SUBJ: **Addendum 1 – Clarifications to the Specifications and Responses to Vendor’s Questions**

BID ITEM: **Bid Item #23-131 Construct Taxiway G for Augusta, GA - Augusta Regional Airport**

ADDENDUM NO. 1

C-301

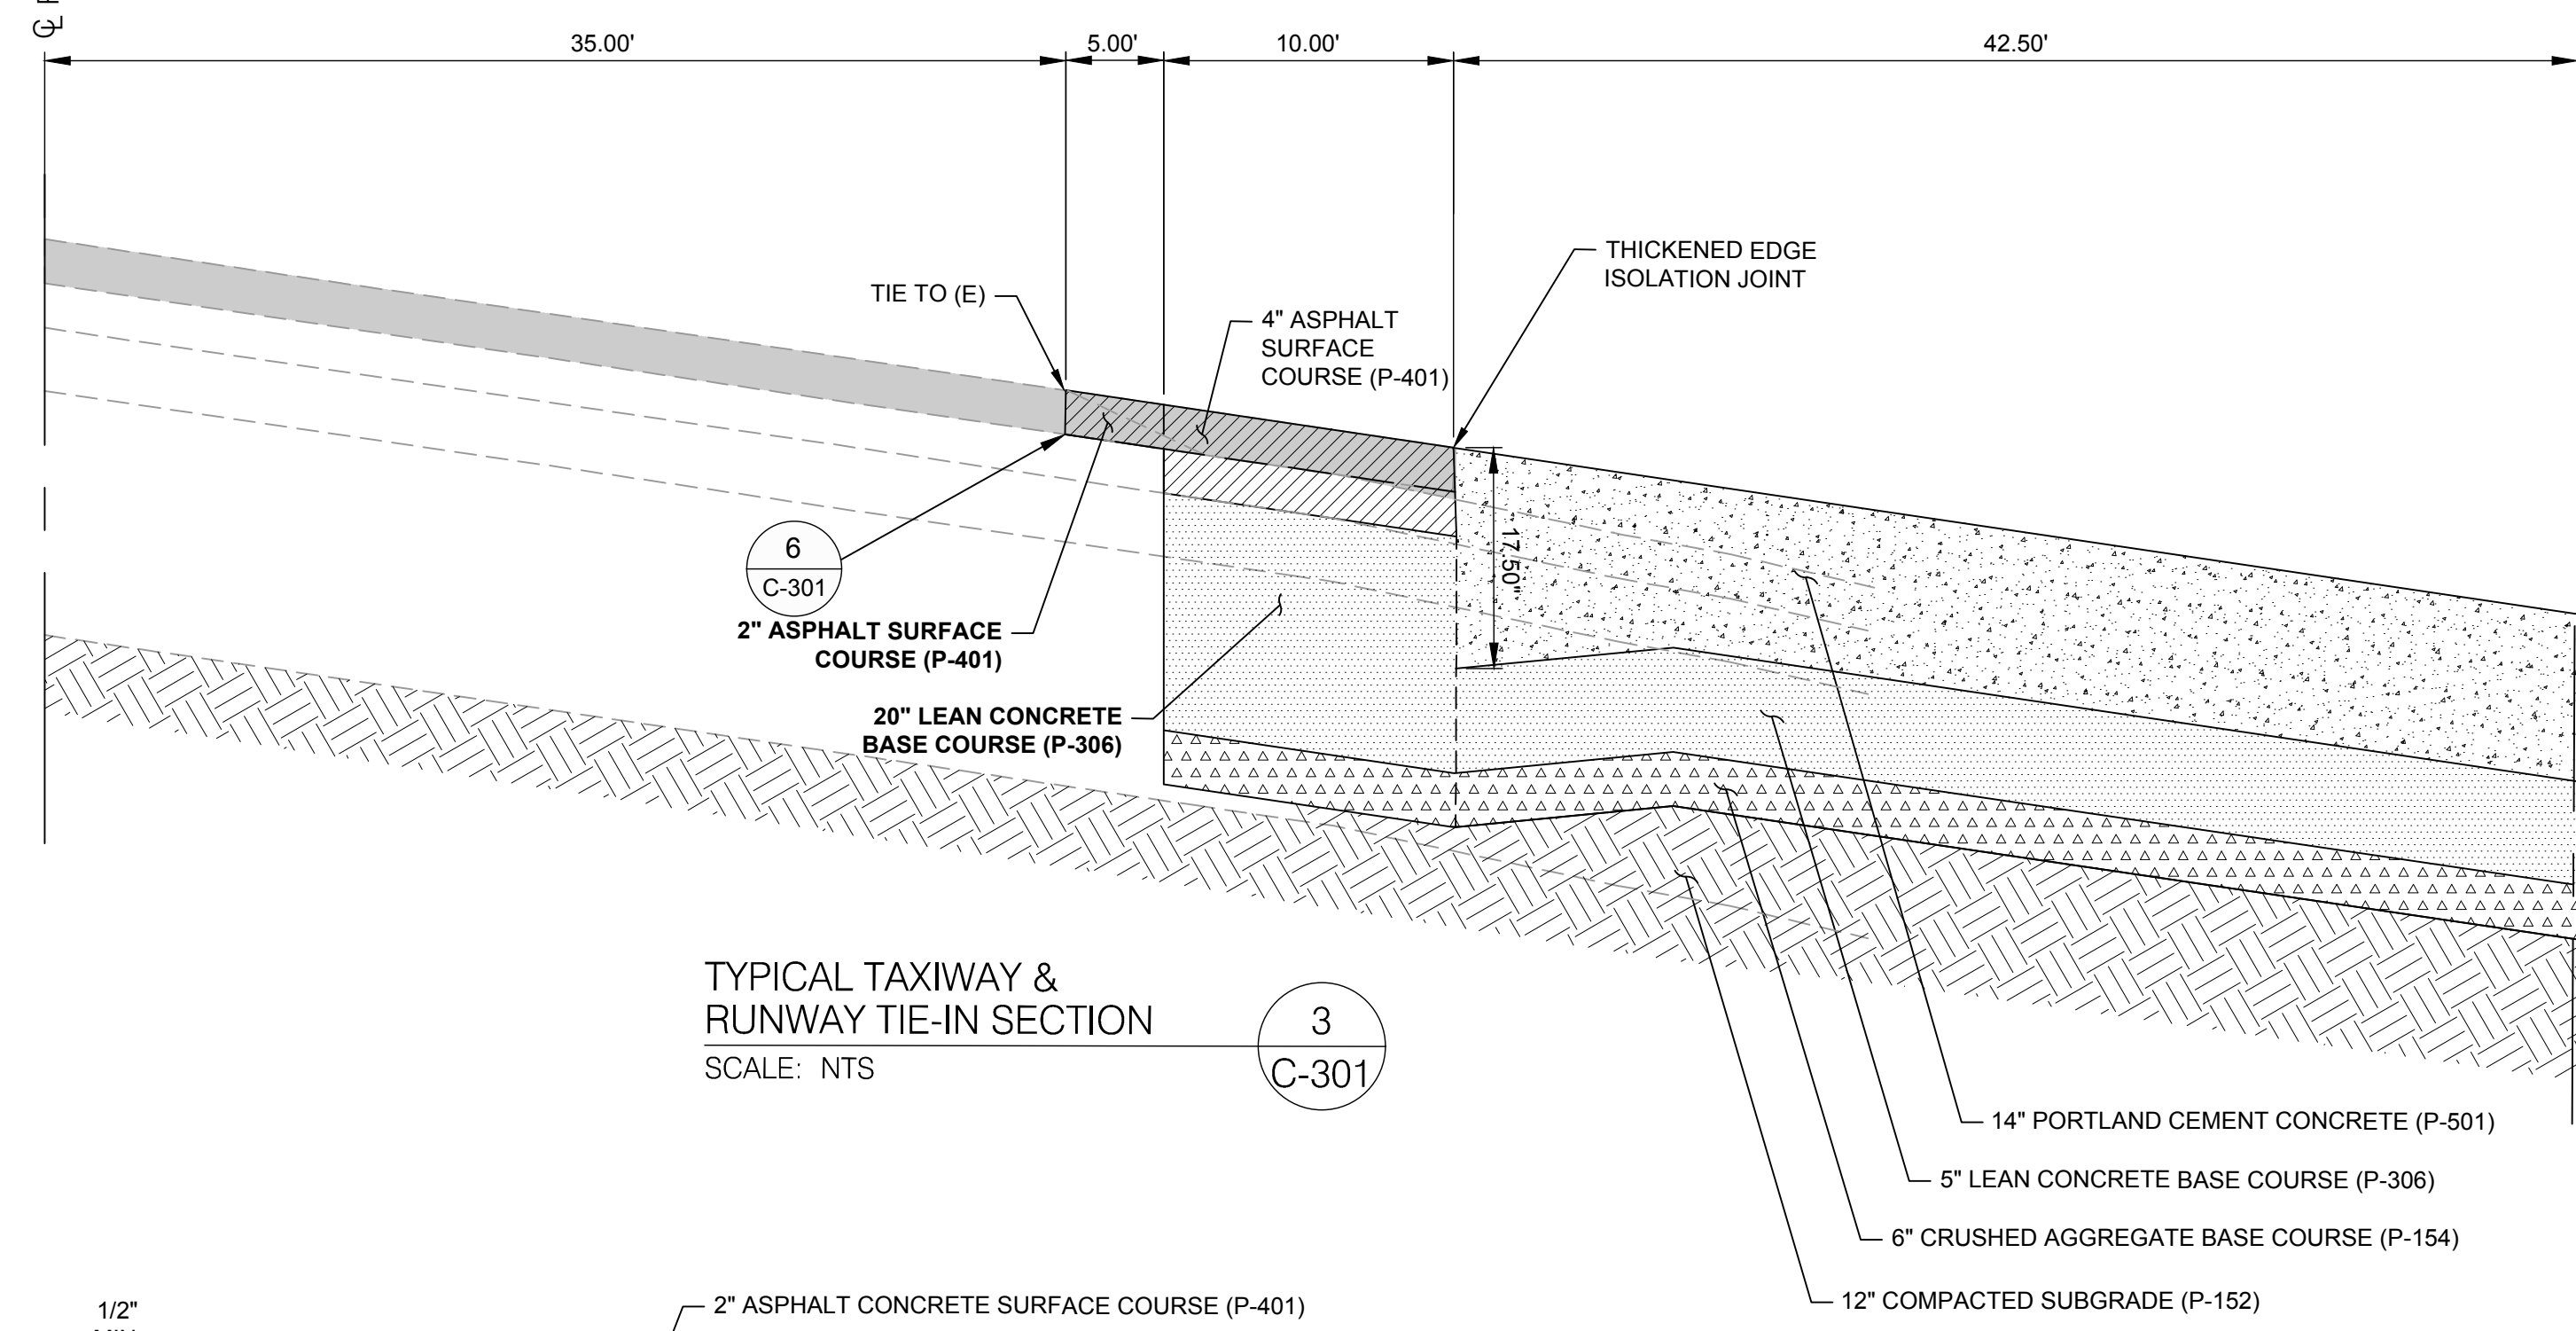
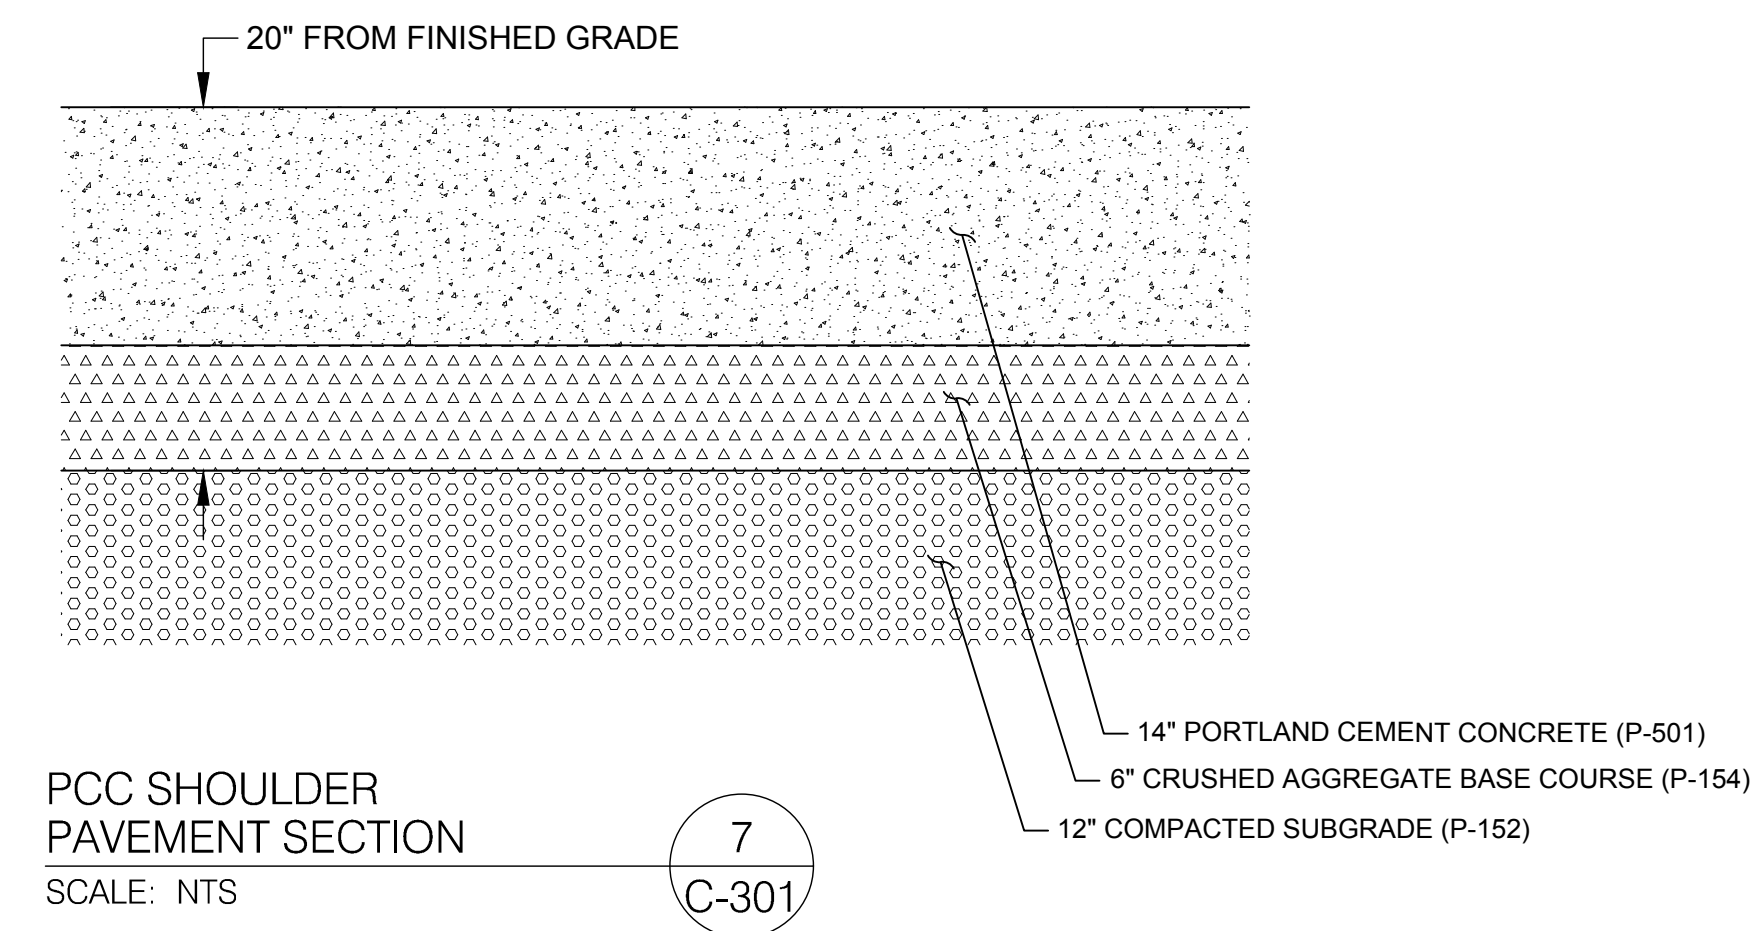
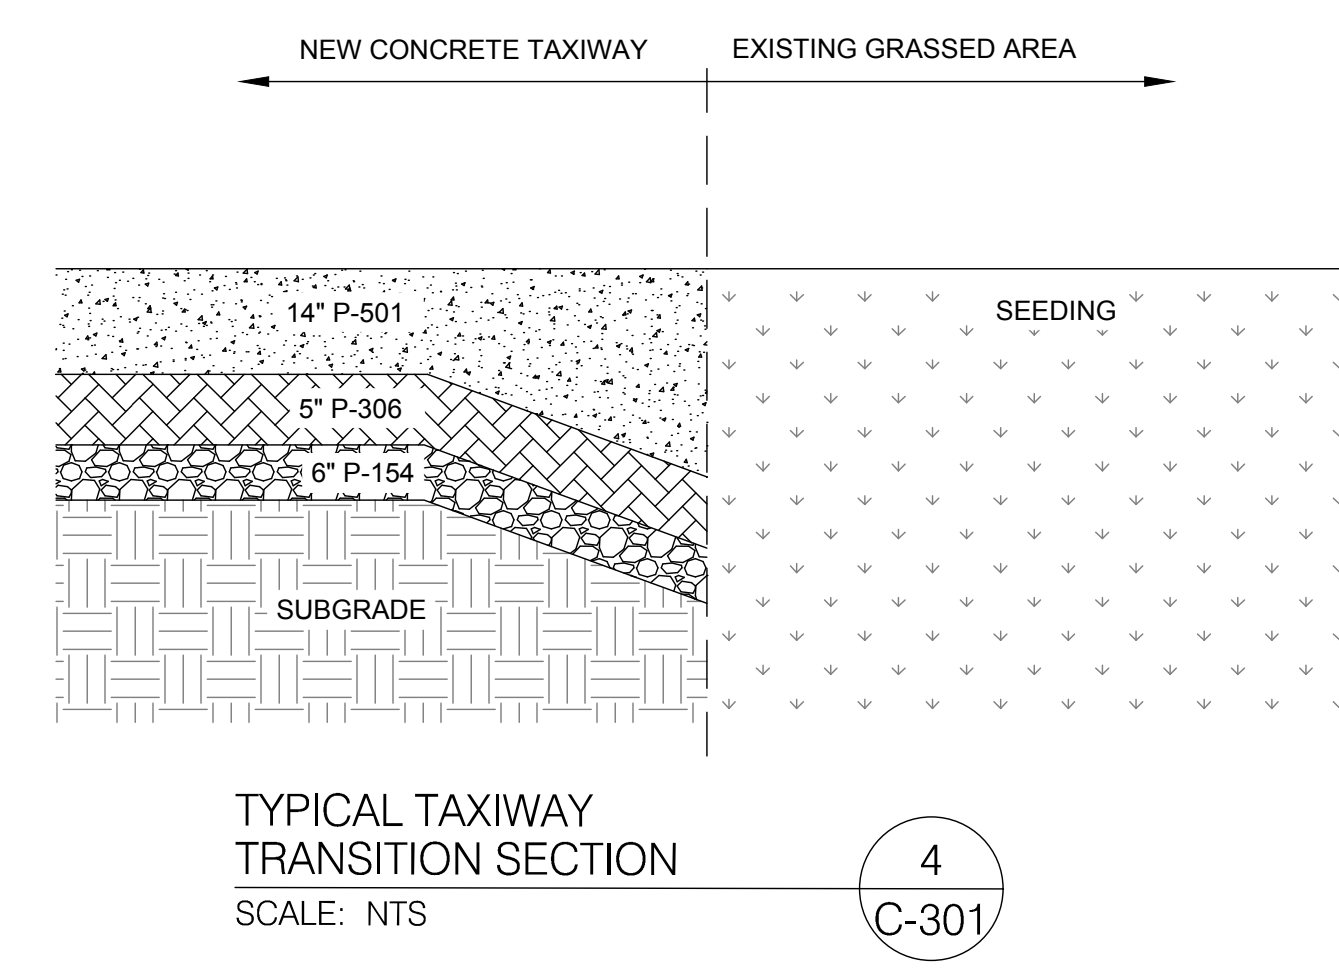
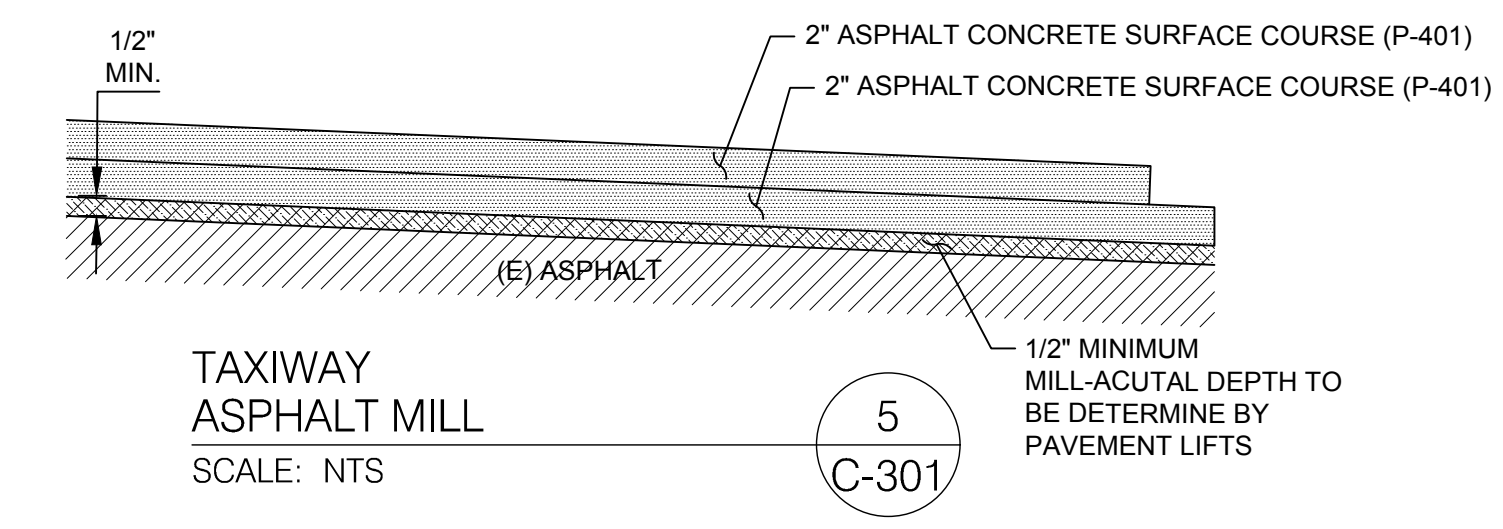
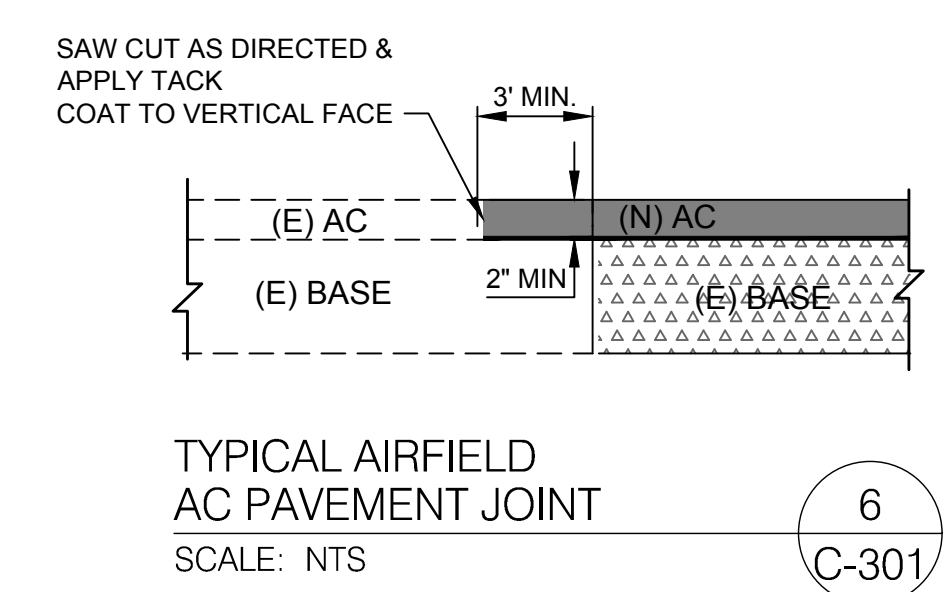
Response: Yes.
13. Question: Can P-304 be used in lieu of P-306?
Response: No.
14. Question: Sheet C-301 detail 3 shows 20" of P-306 in the 10' tie in section. Is this correct?

16. Question: Typical Sections shown on Plan Sheet C-301 show both courses of asphalt as "Asphalt Concrete Surface Course (P-401)", however, the bid form for Base Bid Asphalt Shoulder lists P-401.1 Asphalt Concrete Surface Course and P-403.1 Asphalt Concrete Base Course. Please clarify.

Response: A joint plan for the concrete shoulders shall be provided in the event that the concrete shoulder alternative be awarded.
43. Question: Sheet C-301: Detail 3: How will the 20" P-306/P-304 be paid?

Response: Yes, in order to transfer the load and construct the thickened edge isolation joint.
15. Question: Can a detail be provided for the reinforced panels?

Response: Please refer to the construction drawing change #1 as referenced above.

REVISION
ISSUED FOR BID
REV. 1: CHANGES TO
SHOULDER SECTION CALLOUT
